Trouser World (Pvt.) Ltd.(New Building)

378/1, Kunia, National University, Joydebpur, Gazipur
(23.926324N, 90.387200E)
7th June 2018

Observations

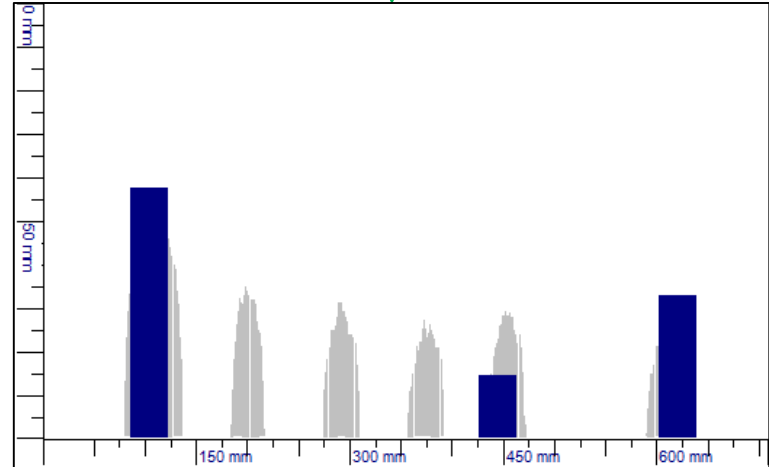
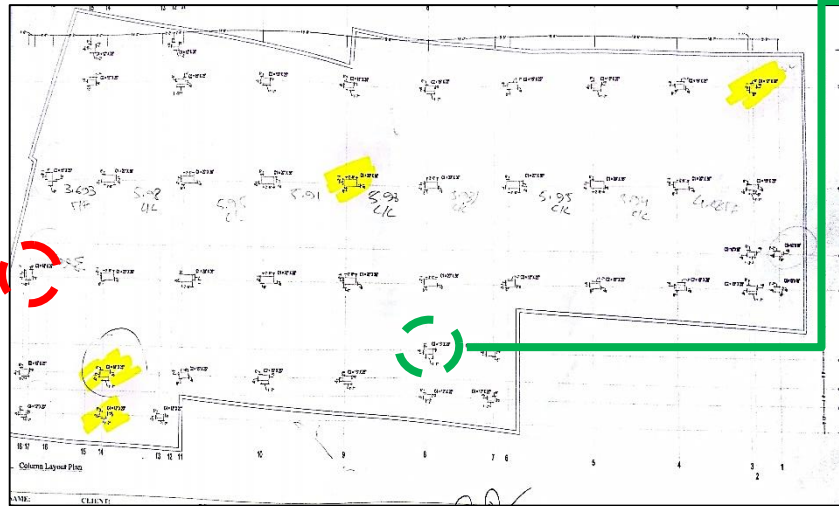
Shaded area indicates beam is missing at eastern side stair.

Shaded area indicates missing beam at southern side stair.

Stair beam was not found as per beam layout plan. Stair beam was found missing in the in the south side and east side stair. One beam was found missing for each stair. Update of as-built drawing is required. Stair stability is required to be assessed.

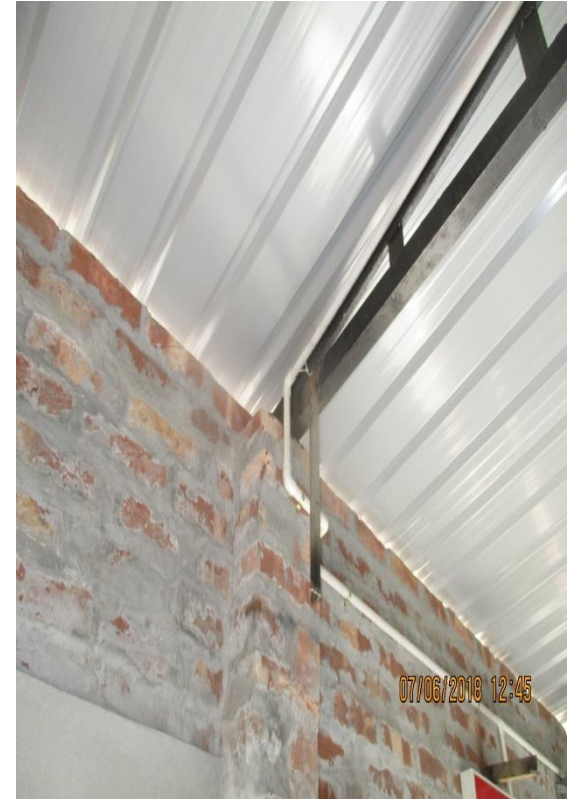
No as-built documents was found for the Dining shed and Utility Building. Factory is required to produce as-built documents for these occupancies.
